STREAMLINED REMEDIATION SYSTEM EVALUATION (RSE-LITE)

CIRCUITRON CORPORATION SUPERFUND SITE
EAST FARMINGDALE, NEW YORK

Report of the Streamlined Remediation System Evaluation,
Conference Call Conducted
August 12, 2004

EPA 542-R-05-004
January 2005
www.epa.gov/tio
clu-in.org/optimization

FIGURE 1-1. SITE MAP AND WELL LOCATIONS

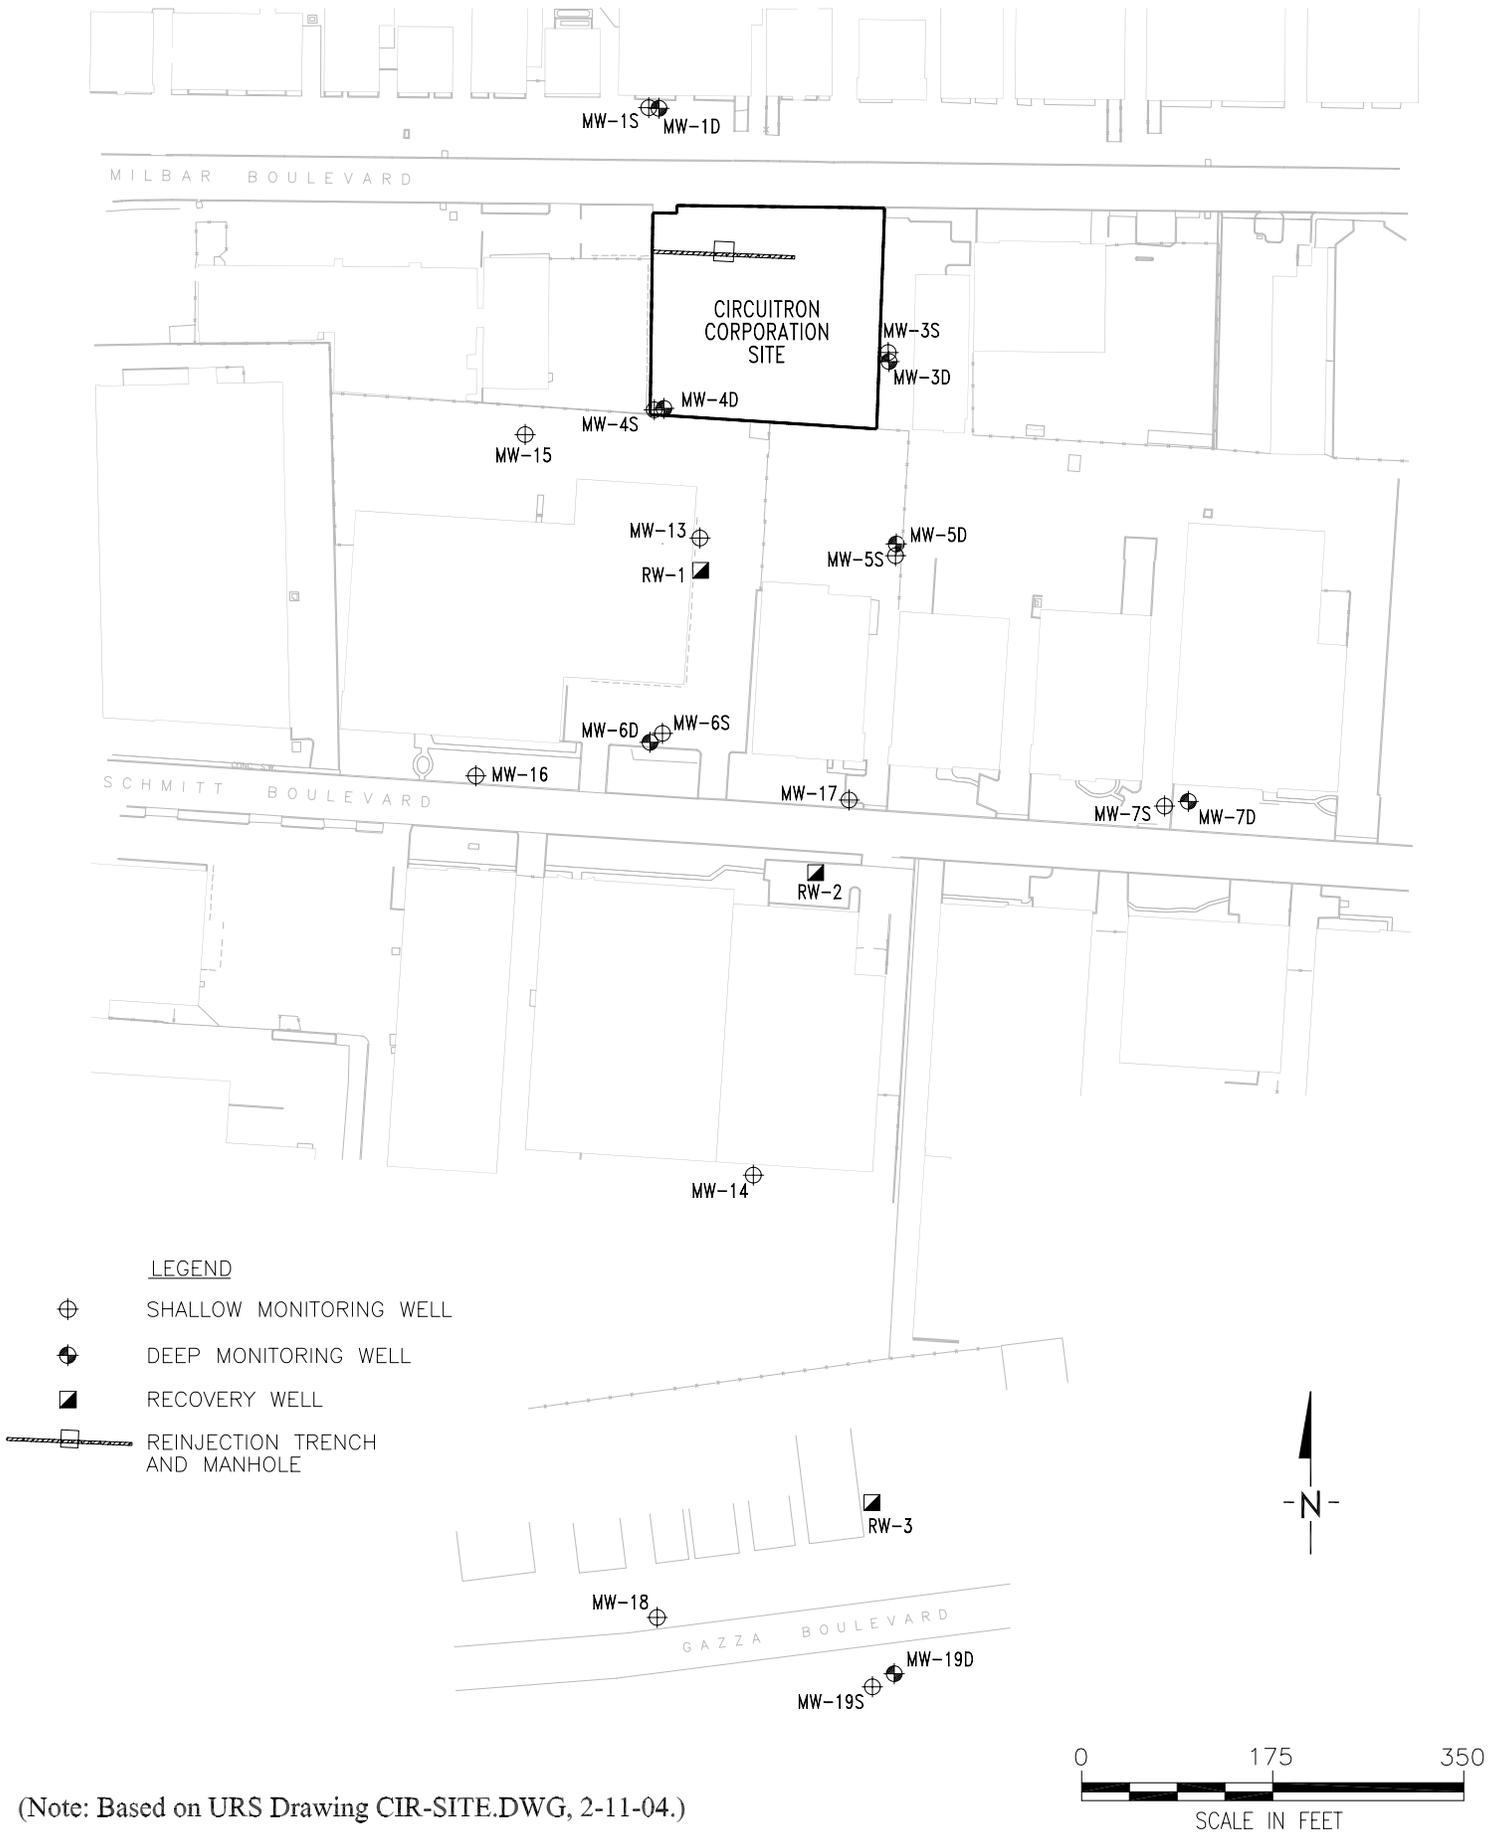
Ground water has not been sampled at the individual extraction wells. However, based on the system influent concentrations and the recovery well locations, it is very likely that RW-2 and RW-3 are pumping water at concentrations below cleanup goals. Sampling should be conducted to verify this hypothesis (estimated one-time cost of approximately \$2,000). If impacts at either of these wells is sufficiently low in the opinion of the site team (presumably at or near cleanup levels for all constituents), the site team should consider eliminating pumping either or both of these wells. The site team has indicated that there are no nearby receptors of immediate concern, the threat of continued contaminant migration beyond these wells is minimal, and the amount of mass being recovered by these wells is likely negligible. This reduced flow rate in the treatment plant will reduce load on the bag filters and the drainage problems at the reinjection trench, which ultimately will reduce costs. Electrical costs will also be reduced. Specific cost reductions from this recommendation are quantified as part of other recommendations (6.2.3 and 6.2.4). These wells could subsequently be added to the monitoring program after shutdown, but existing monitoring wells likely provide sufficient spatial coverage.
